PLAN COMMISSION/HISTORIC PRESERVATION COMMISSION

WEDNESDAY, JUNE 24 2020

To: Village of Mount Horeb Plan Commission
From: Village Planner Michael A. Slavney, FAICP
Date: June 16, 2020
Re: Village Planner's Planned Development -- Specific Implementation Plan (SIP) and Design Review Comments for Proposed Landsby Ridge Affordable Housing Development for June Plan Commission Review

Sheet No.
202

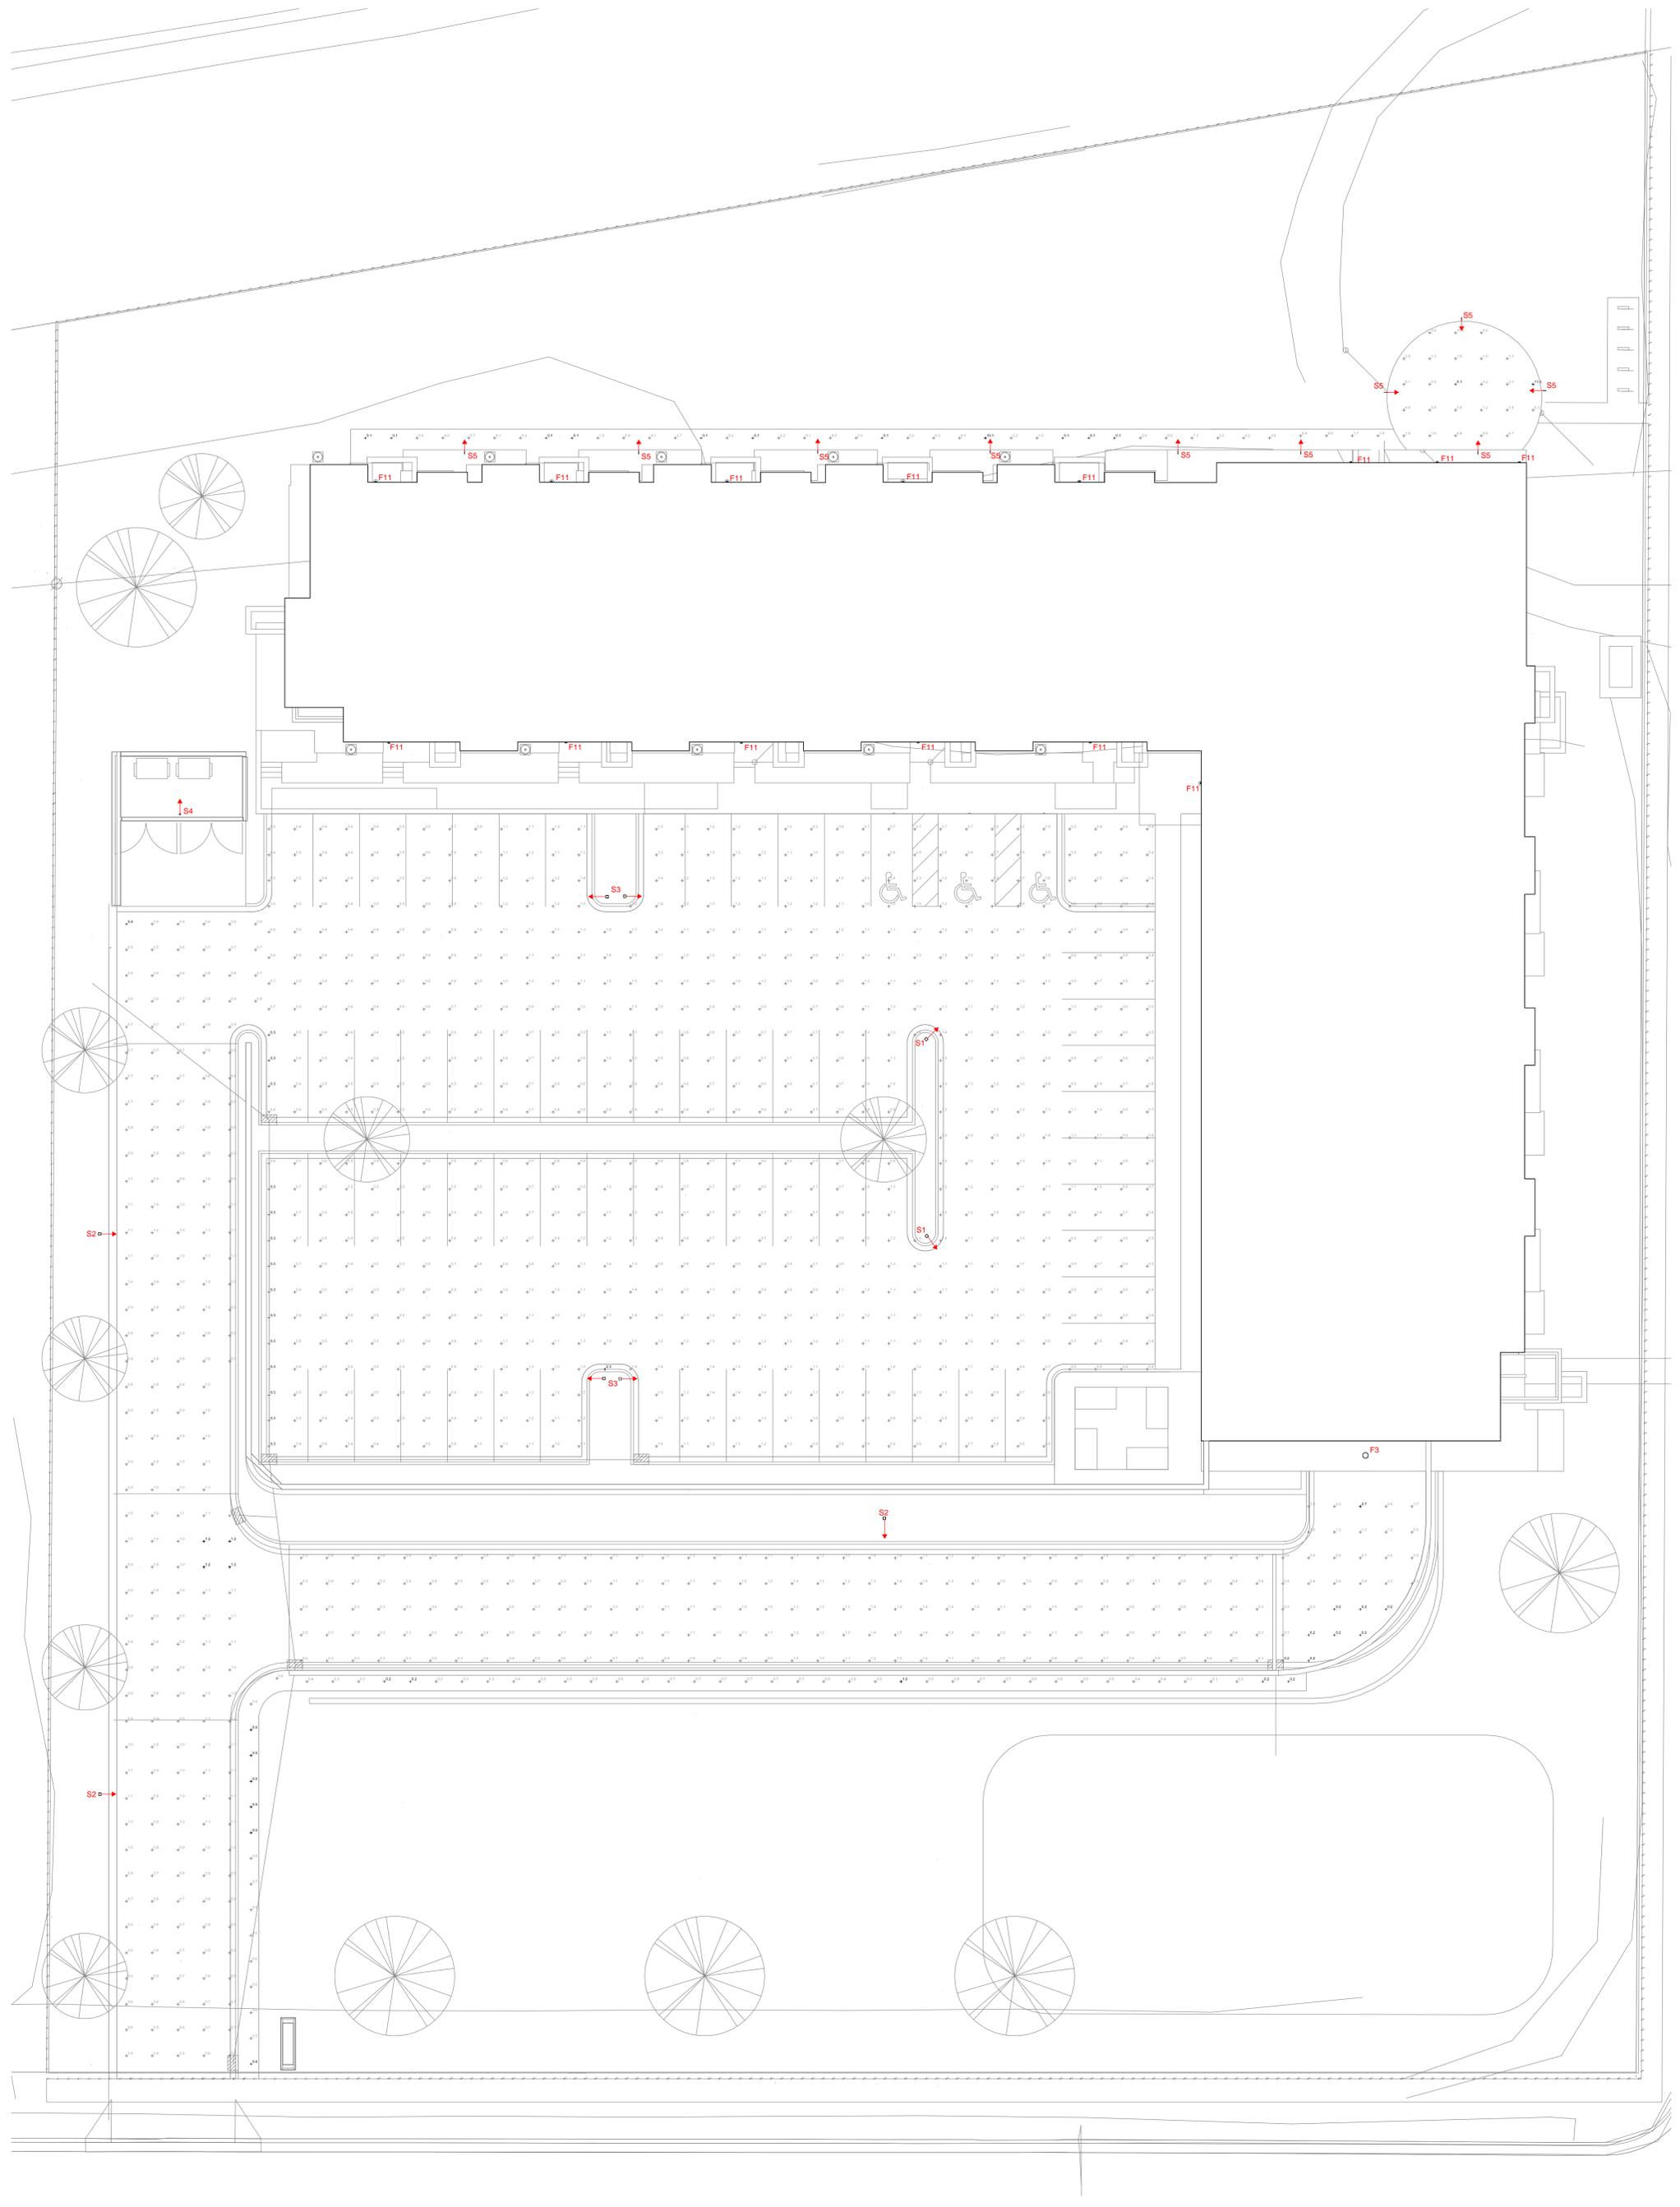
- This requirement is not met with the proposed wall materials, which include metal wall panels. The developer has proposed the use of metal panels on a relatively low percentage of the building façade area – labeled as “MP-1” on the elevation drawings – wrapping the northeast corner of the building for the north and east facades. *The Plan Commission will need to consider an exemption for the use of metal panels.*

- This requirement is not met on most of the lower walls of the building – where conventional siding extends to the concrete foundation. The use of siding below the first floor window sills will allow damage to the siding. *The Plan Commission will need to consider an exemption from this standard.*

- iv. Color patterns shall be used consistently throughout the property, as determined by the Plan Commission.
 - A variety of colors and materials are depicted on the building elevations – in some locations in an unconventional arrangement. *The Plan Commission should discuss whether this requirement is met on all portions of the building.*
